FAA Anchorage ARTCC

Response to Pacific Project Action Item PP08-03 “UPR Expansion”

Presented to: Cross Polar Working Group / 19

Date: May 11-15, 2015

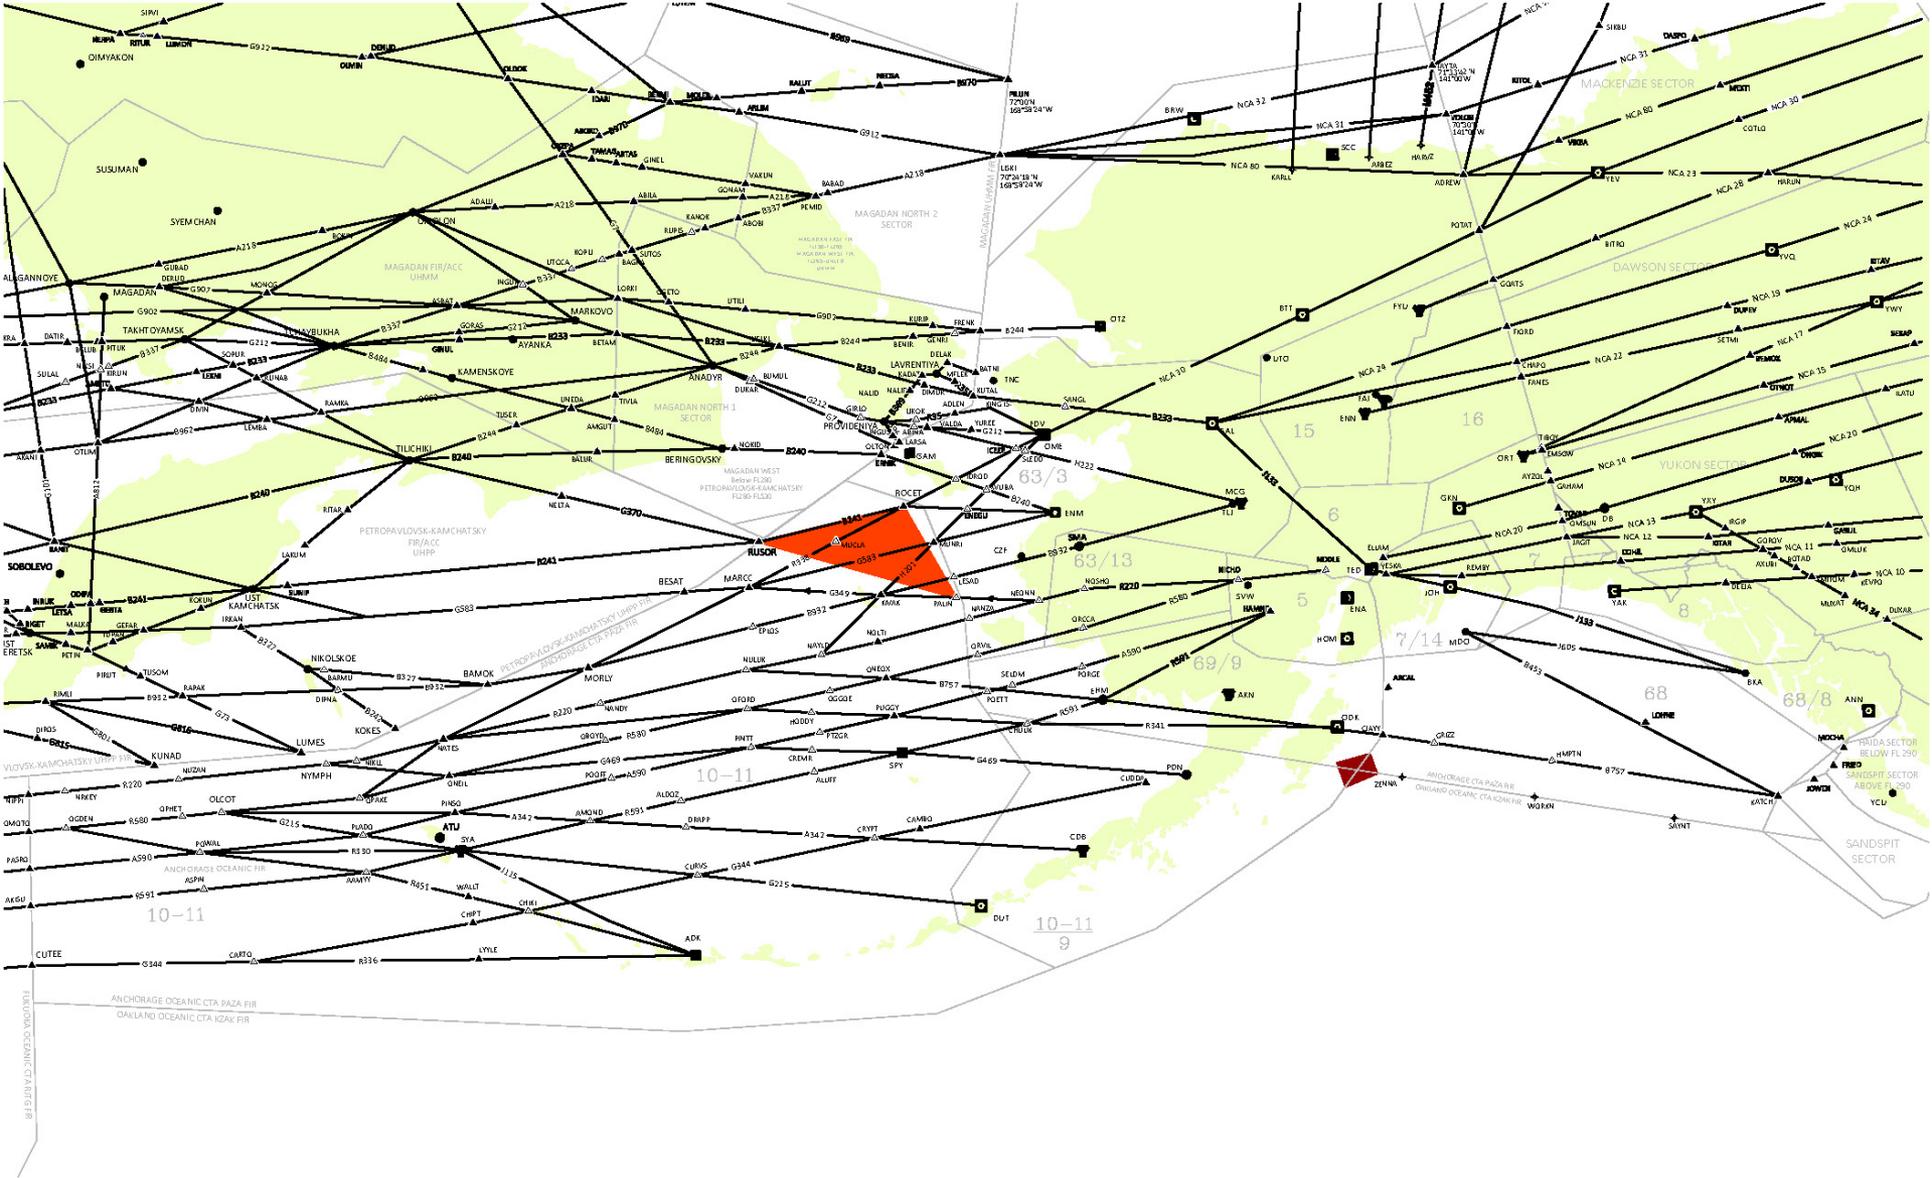
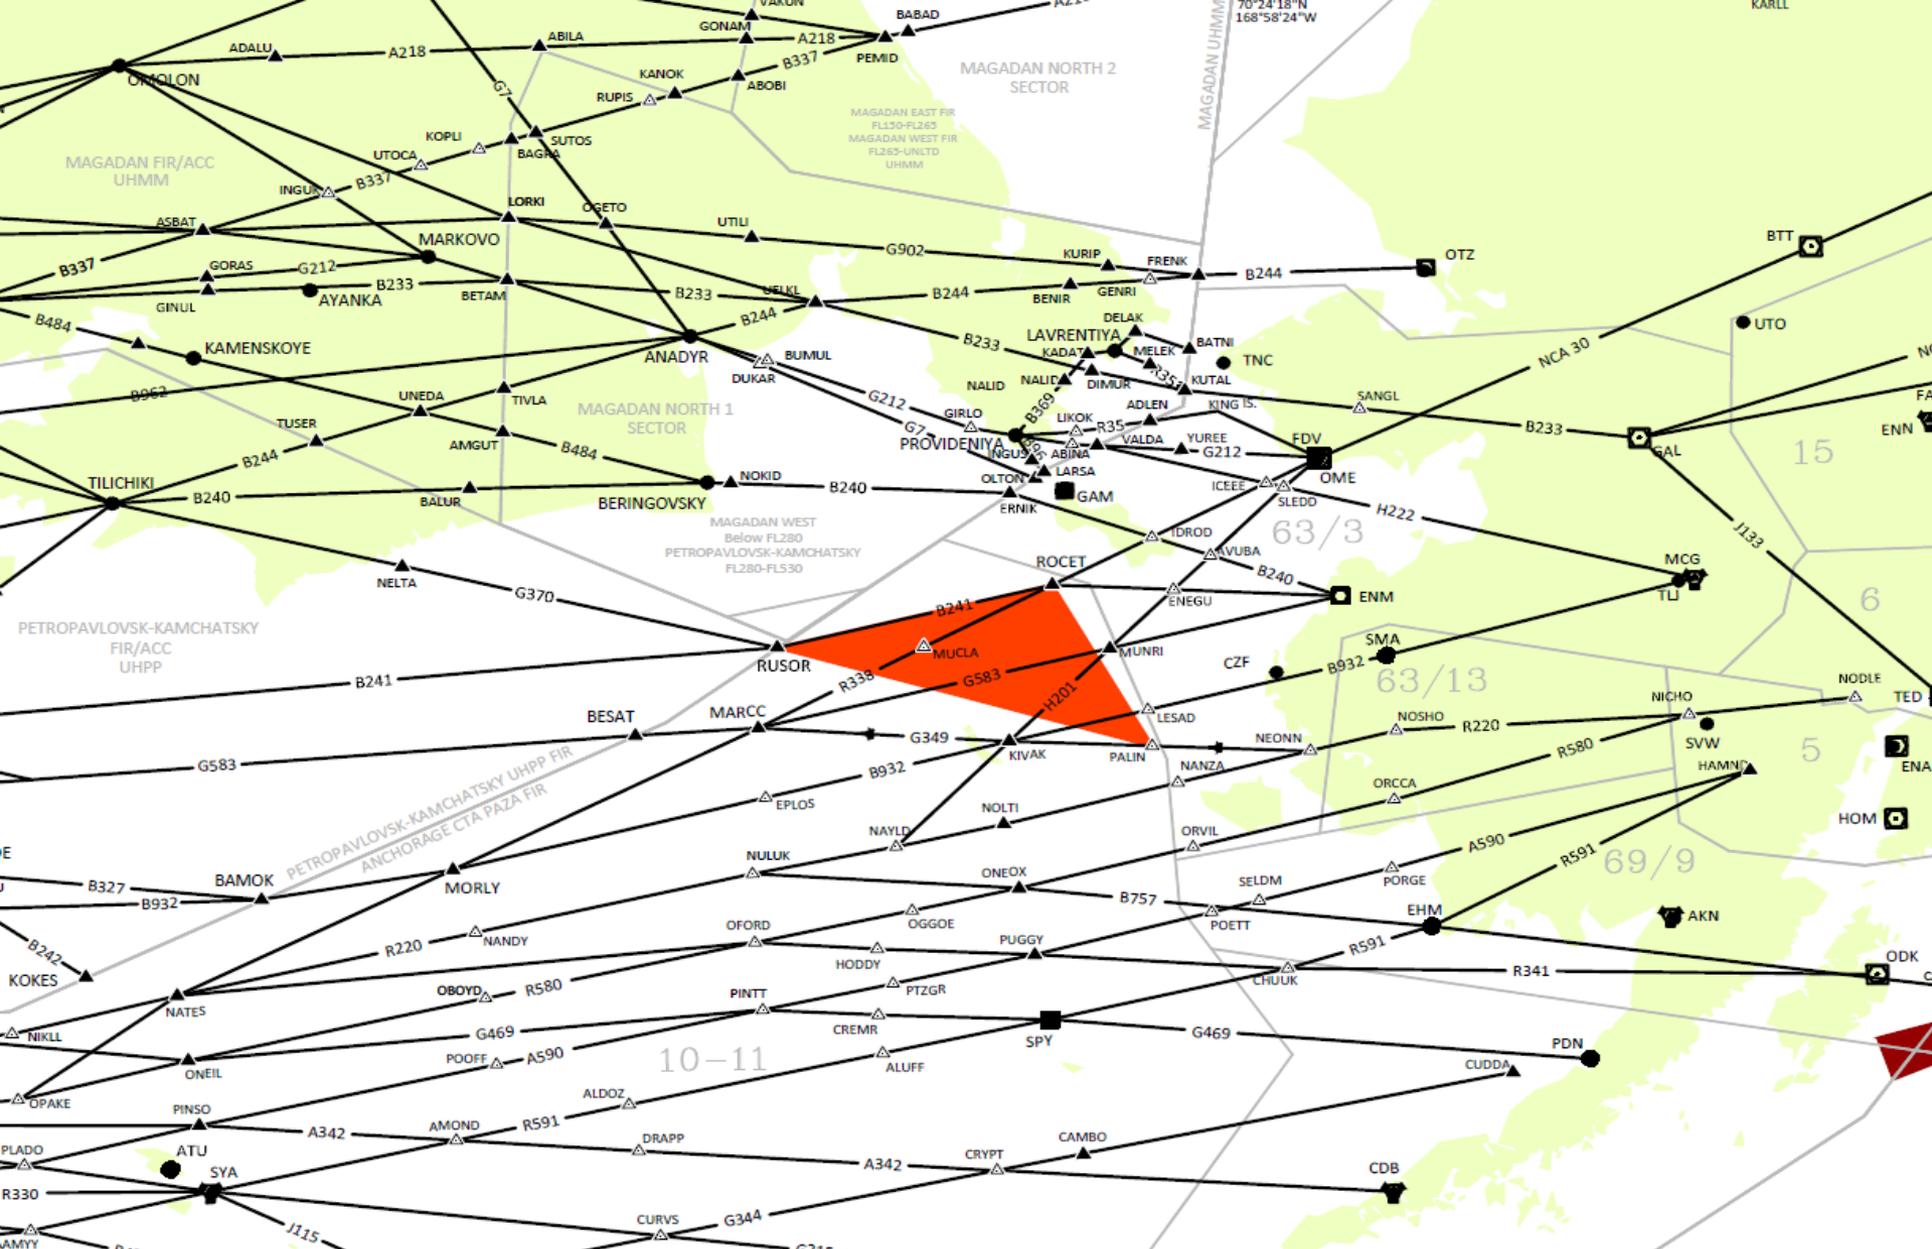
a. Reference the restrictions applicable to all entry fixes: the action group found that the language used to describe the southern restriction, “Anywhere between KATCH and...” would be improved by clarifying the relationship with the earlier, “must avoid” airspace description. Accordingly, the Anchorage (PAZA) UPR NOTAM was reissued to state that westbound aircraft may enter PAZA FIR airspace:

- ANYWHERE BETWEEN KATCH AND 5638N15059W PROVIDED THE FLIGHT OVERFLIES ONE OF THE FOLLOWING: KATCH, HMPTN, GRIZZ, OR CJAYY.**
- ANYWHERE OVER OR BETWEEN 5626N15217W AND 4746N17000E.**

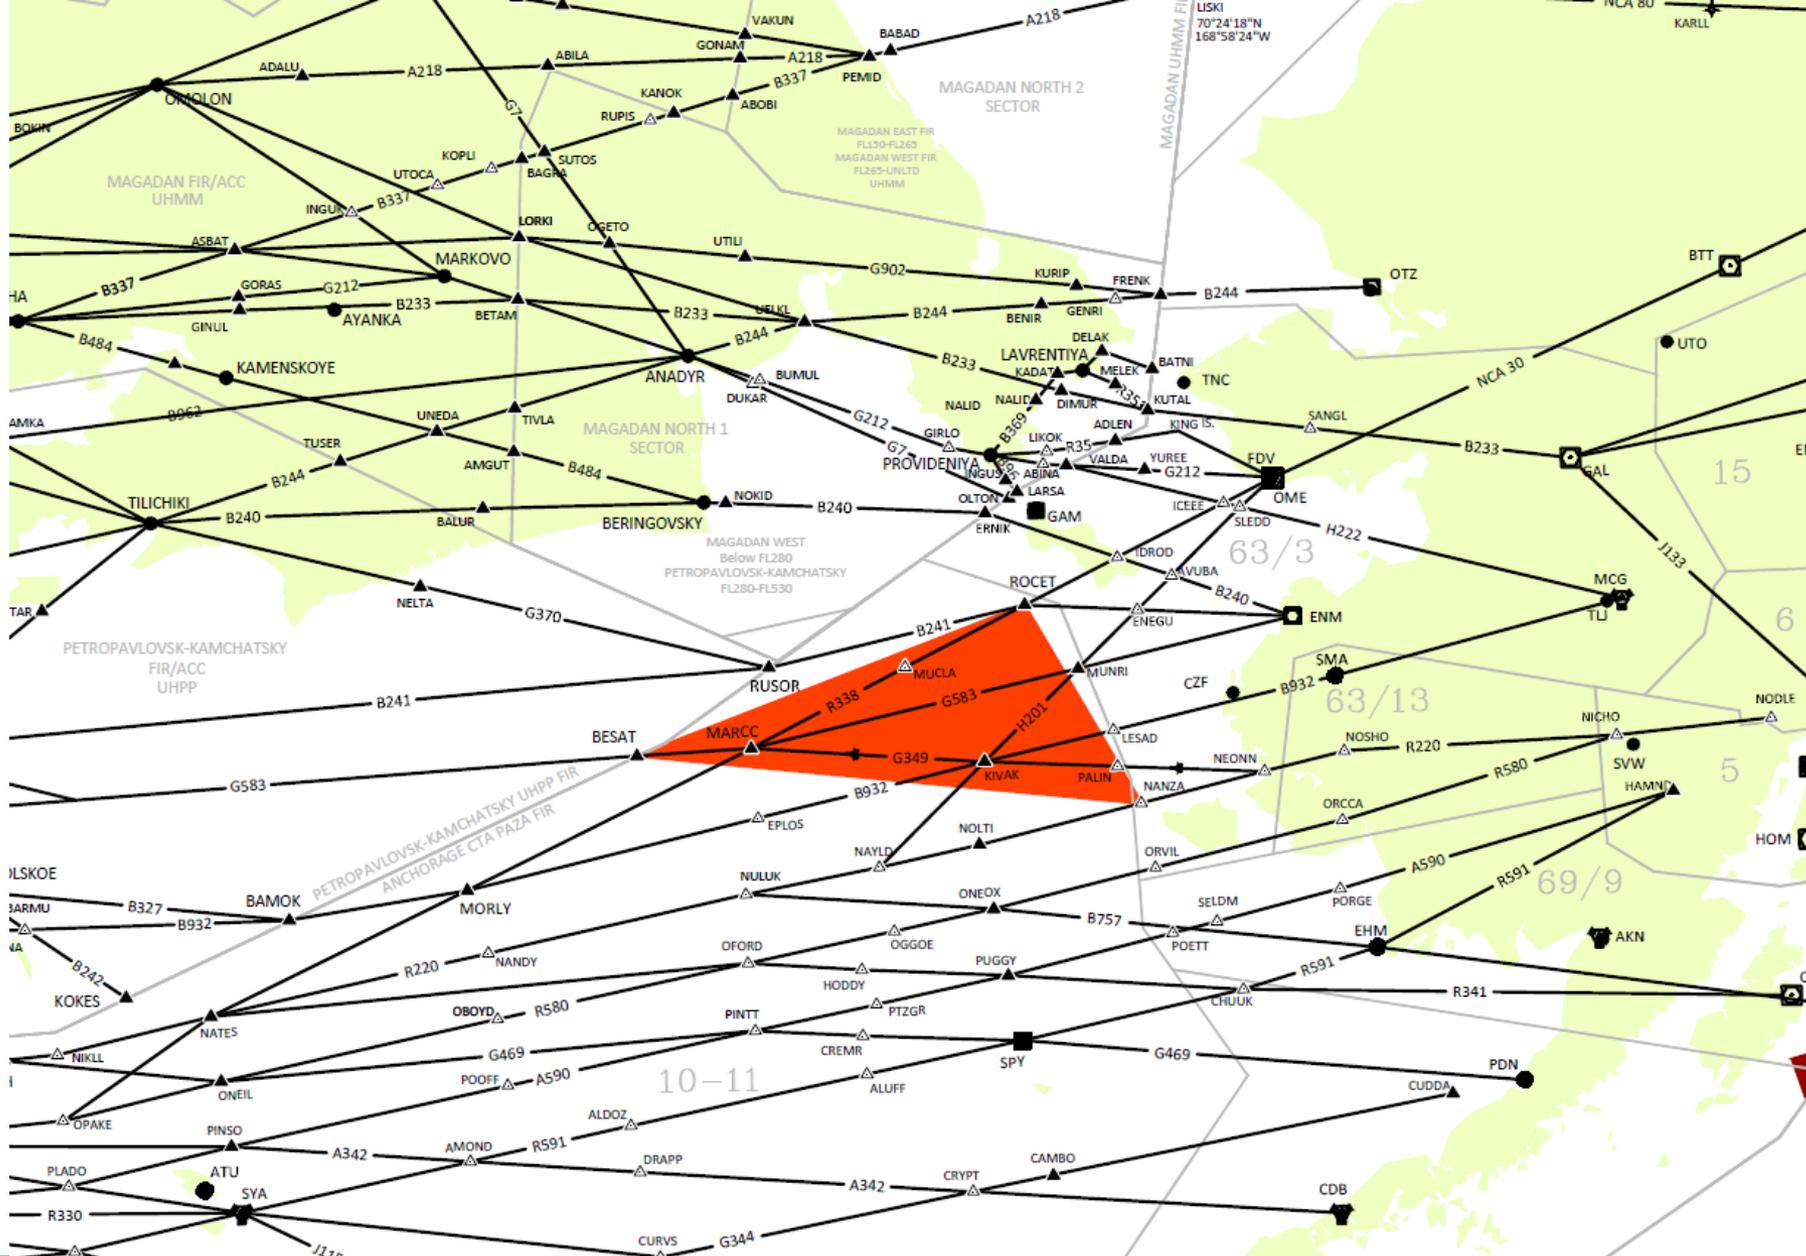
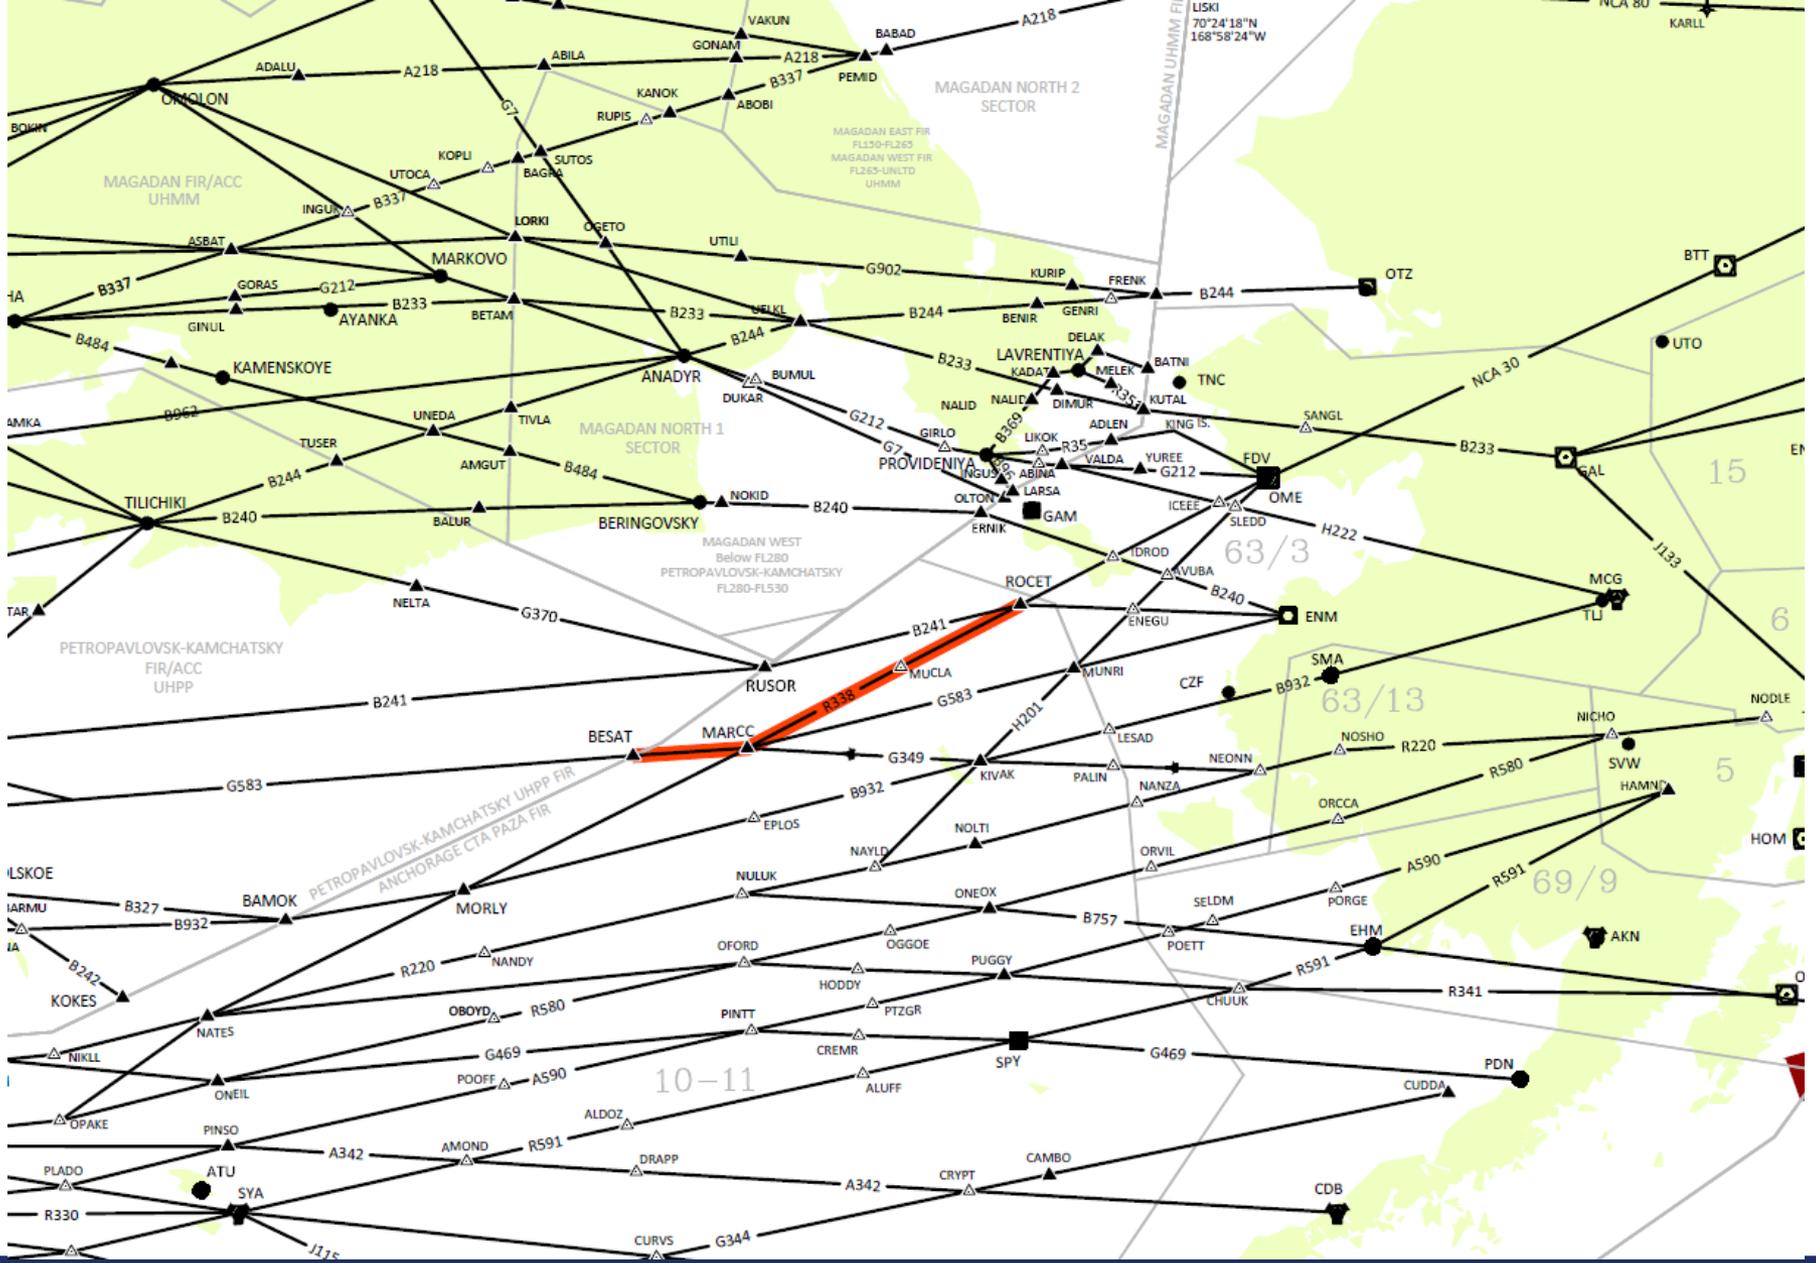
b. Reference RUSOR: the action group found that the need for the current westbound restriction remains valid, but that current language is too restrictive. Accordingly a revision to the Supplement, Alaska publication has been requested to change this restriction to state that aircraft must flight plan, “on, or south of, a line ROCET direct RUSOR and on, or north of, a line PALIN direct RUSOR.” The action group found that both the need for, and the language of, the eastbound RUSOR restriction remains valid and appropriate.
